SUBJECT: CRYSTAL RIVER NUCLEAR GENERATING PLANT UNIT 3 - ISSUANCE OF
LICENSE AMENDMENT RE: LICENSE CONDITION 2.C.(5) FOR FLOW
INDICATION (TAC NO. M99120)

Amendment No. 164
License No. DPR-72

SAFETY EVALUATION BY THE OFFICE OF NUCLEAR REACTOR REGULATION
RELATED TO AMENDMENT NO. 164 TO FACILITY OPERATING LICENSE NO. DPR-72

Figure 12. Core Boron Concentration Control Limits.

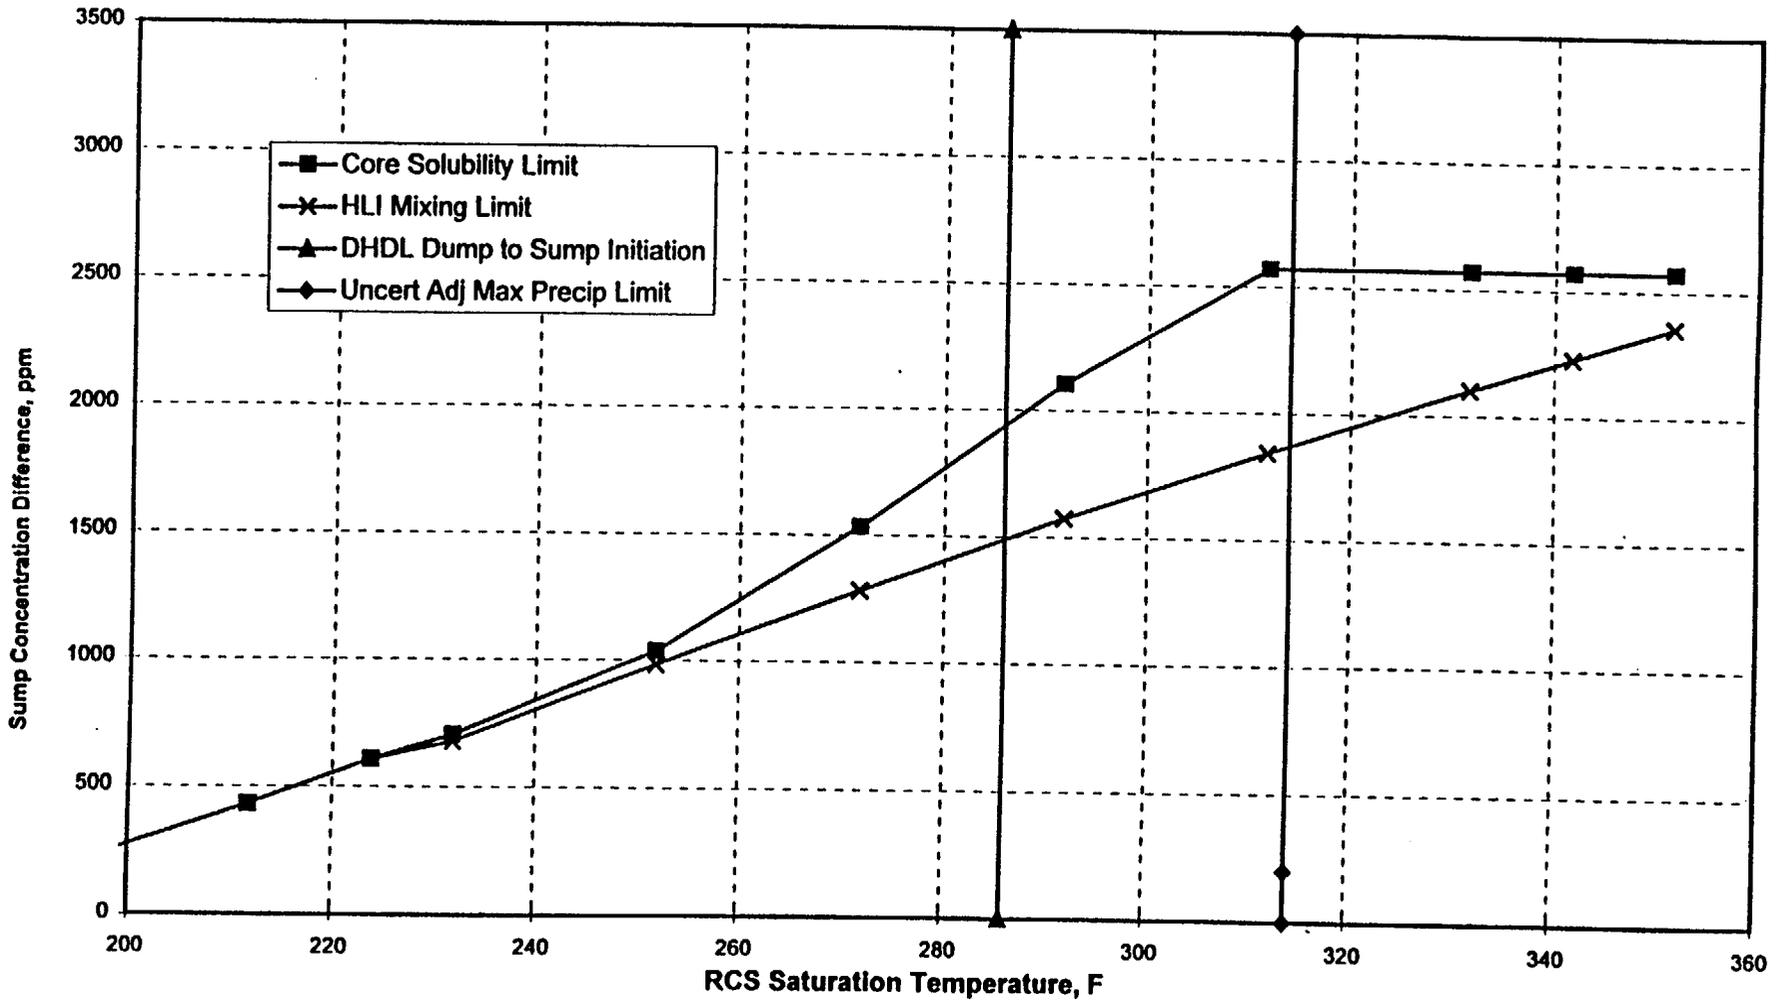
- (1) Calculation of acceptable boron concentration in the core as a function of incore water temperature indication using calculation methods the staff has previously accepted.³⁴
- (2) Calculation of sump boron concentration that would exist for the core boron concentration calculated in step 1 if water in the bottom of the reactor building, including the sump, is well mixed.
- (3) Calculation of sump boron concentration that would exist if no boron concentrated in the core.
- (4) Plotting Item 3 minus Item 2 (ΔC) as a function of incore temperature indication. This correlation is provided as Attachment 1 to this SE.

An observed value of ΔC below the plotted line, with acceptable allowance for concentration nonuniformity and delay times, indicates an acceptable core boron concentration and is a safe operating region. A value above the line is an indication that more boron has accumulated in the core than permitted, and is unacceptable.

FPC will apply a 25% safety factor (multiply ΔC by 0.75) to Curve 1 discussed above. The correlation would be applied following a LOCA unless (1) the time has been too short for core boron concentration to reach the saturation curve (Item 1, above) or (2) if incore temperature indication shows that an adequate subcooling margin has been established for a sufficient time to ensure that boron precipitation cannot occur. By letter dated January 19, 1998, the licensee stated that boron sump concentration monitoring is in a controlled procedure. In its January 19, 1998 letter, the licensee stated that "[A] 25 % factor of safety has been applied to the Reactor Building (RB) Emergency Sump boron concentration difference curve. This factor of safety has been required for use except when either of the following conditions apply:

Based on the above, the staff finds this correlation with application of the 25% safety factor acceptable. By this amendment, the staff requires that this procedure be described in the next update of the FSAR.
